Access Compliance Report

Public Rights-of-Way

(Curb Ramps)

Intersection ID: 3033	Main Street: DEARMON_RD	Cross Street: BENFIELD_RD	Location:	N
ADA ID: B3992CBDB074	Ramp Type: BlendTrans1	Initial Pass/Fail: Pass	Overall Compliance: No	Severity Score: 0
Codes/Mitigation Info/Possible Solution		Field Measurements/Component Compliance

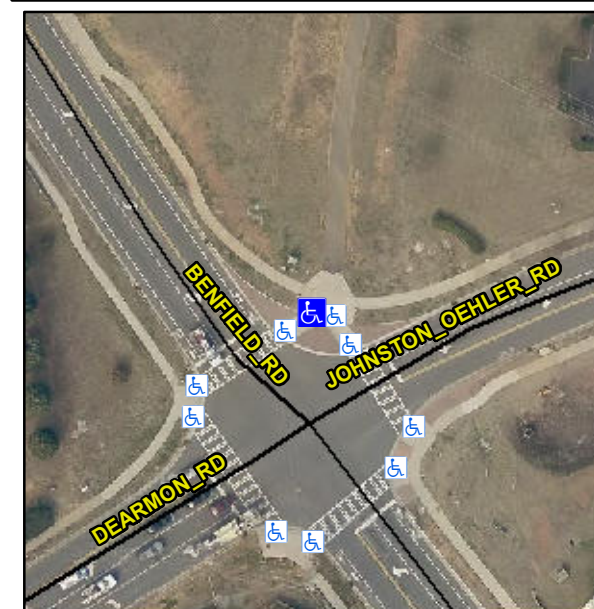
Not Found, R304.2.3, R305.2, R304.5.4, R304.5.3

Remove & Replace Curb Ramp With Two New Directional Ramps or Equivalent. Remove & Replace Gutter.
